Landscape Referral Response

Application Number:	Mod2023/0479
Date:	19/12/2023
Proposed Development:	Modification of Development Consent DA2021/2034 granted by the Land and Environment Court for demolition works and construction of a residential flat building
Responsible Officer:	Thomas Prosser
Land to be developed (Address):	Lot 50 DP 705739 , 30 Fairlight Street FAIRLIGHT NSW 2094

Figure 1 below:

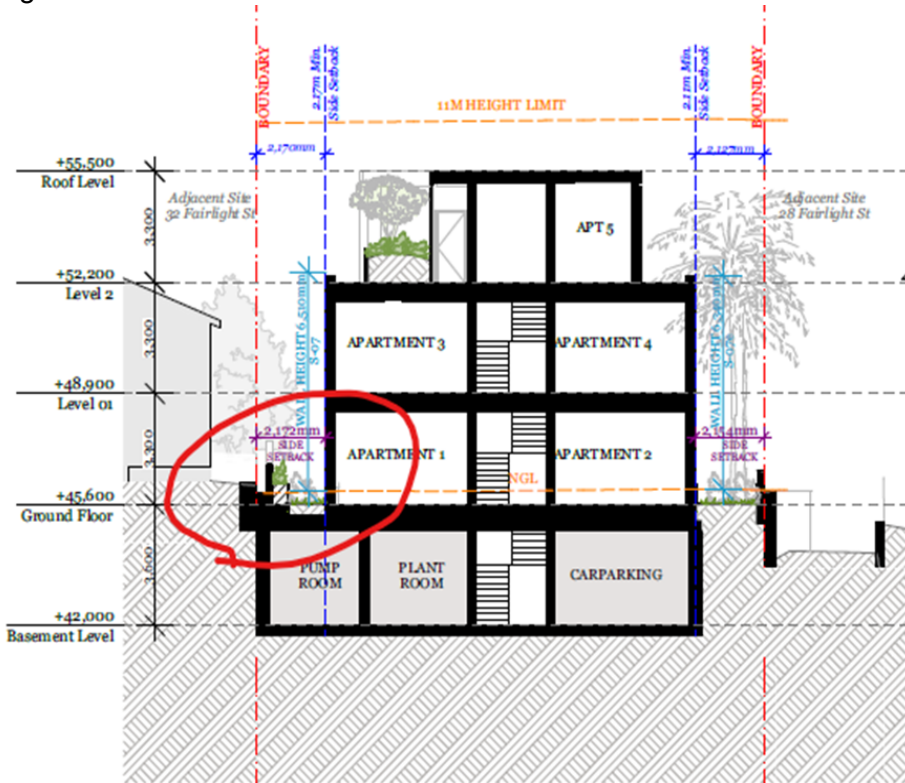
The approved Court landscape outcome includes soil within planters over structure, to apartment 1 ground level, as illustrated in figure 1, and there is no valid reason to alter this. As such the Court

Amended Plans (not limited to but including Architectural and Landscape Plans) shall be submitted to the Principal Certifier illustrating the following to the ground level of apartment 1 over the OSD tank structure:

- delete paving and restore planting of approved landscape scheme, as shown below:

Figure 2 below:

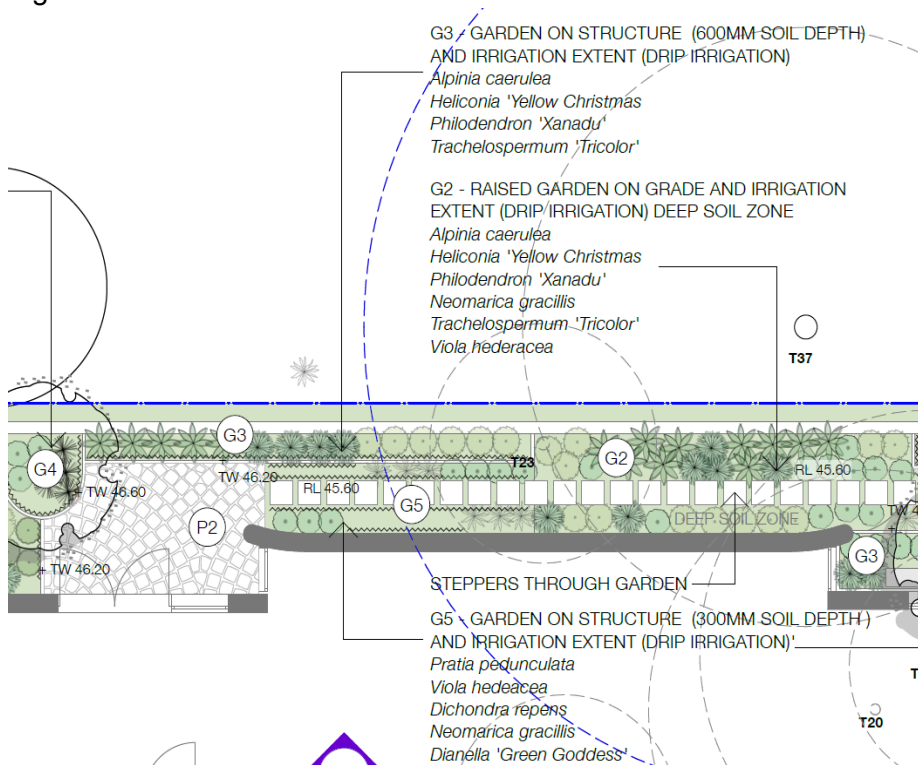
approved landscape outcome (over structure ie. OSD tank) as illustrated in figure 2 shall remain, and conditions shall be imposed.
